DOCKETED	
Docket Number:	26-TIRE-01
Project Title:	Tire Efficiency Rulemaking
TN #:	270652
Document Title:	Br Comments - Bridgestone Comments on CEC Replacement Tire Efficiency Program
Description:	N/A
Filer:	System
Organization:	Br
Submitter Role:	Public
Submission Date:	6/16/2026 7:51:59 AM
Docketed Date:	6/16/2026

Bridgestone Comments on CEC Replacement Tire Efficiency Program

RE: Comments on Tire Efficiency Rulemaking (Docket No. 26-TIRE-01)

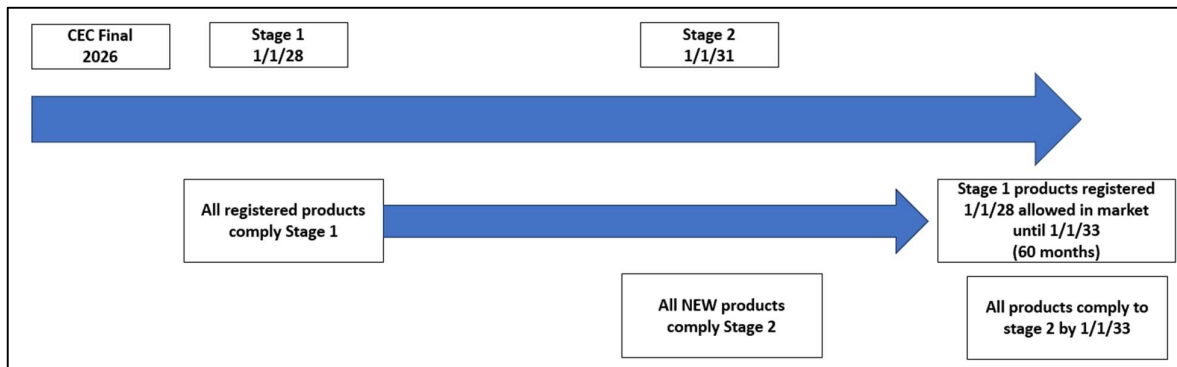
Bridgestone supports CEC’s categorization of Low-Load-Index-Tires and acknowledgement that load index plays a role in rolling resistance performance. Bridgestone requests that CEC amend the definition of Low-Load-Index-Tires to be defined as those with a load rating of 94 or less, as it

more accurately captures the performance gap between low load index and rolling resistance than the proposed definition of load rating 91 or less.
